CDM: Recommendation Form for Small Scale Methodologies (version 01)
(To be used for presenting questions/proposals/amendments to the simplified methodologies for small-scale CDM project activity categories)

Date of SSC WG meeting:	15–18 June 2010, SSC WG 26
Title/Subject (give a small title or specify the subject of your submission, maximum 200 characters):	Clarification on the treatment of back-up unit for establishing the installed capacity under AMS-I.C
Indicative methodology to which your submission relates (refer the items of Appendix B of the Simplified Modalities and Procedures), if applicable.	AMS-I.C “Thermal energy production with or without electricity”
Name of the authors of the query:	Jung, Jae Su / Kim, Mi-yeon Institution: Ecoeye.Co.Ltd. / Korea District Heating Corp. civilenvi@ecoeye.com , kmy97@kdhc.co.kr

The following figure describes system diagram of project activity.

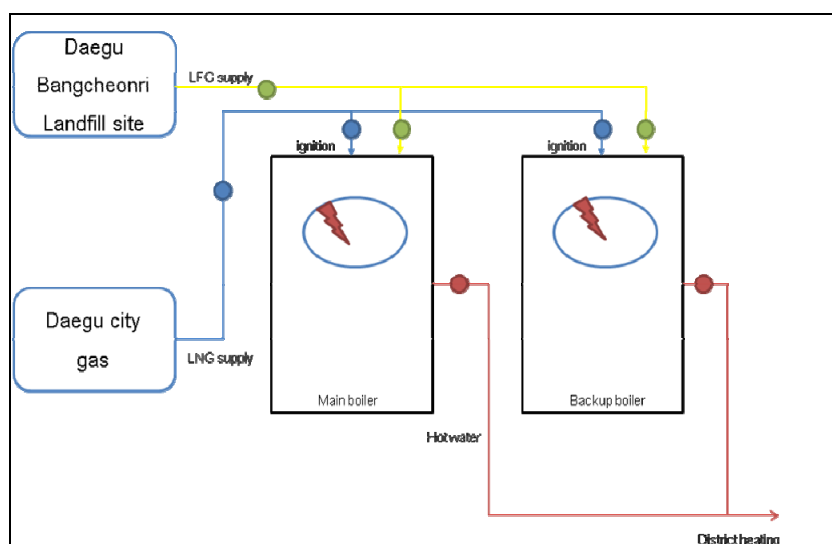
In this case (d), the capacity of common system is designed for supplying hot water produced by two boilers. It is considering increasing hot water demand. It is judged that joining Main boiler and Back-up unit point is common system.

If use of Back up boiler using LNG increases by operating two boilers at the same time, it isn't calculated at Emission Reductions. Because baseline scenario of project activity is conservatively applied to installation LNG boiler for district heating.

Then the project requests clarification which is including both Main boiler and Back-up in the physical boundary and it is wondering whether it is possible to apply the small scale methodology when the project estimates the installed capacity except for Back-up boiler capacity.

The SSC WG did not agree that there is justification for relaxing the criteria defined in SSC_336 for excluding stand-by (or backup) unit(s)/system(s) from consideration in the determination of installed capacity limits and debundling check. The author indicates that their project does not comply with criteria "d":

Therefore, both boilers shall be considered in the determination of installed capacity limits and debundling check. That “maximum of the expect[ed] quantity from Daegu Bangcheon-Ri Landfill doesn’t exceed the capacity of the boiler during crediting period” is not sufficient to ensure that both boilers will not be operated at the same time (violating criteria “a”) to meet existing, or the potentially implied, increases in hot water demand. The project proponent may still consider the project, if it exceeds the small-scale limits, as a large-scale project.
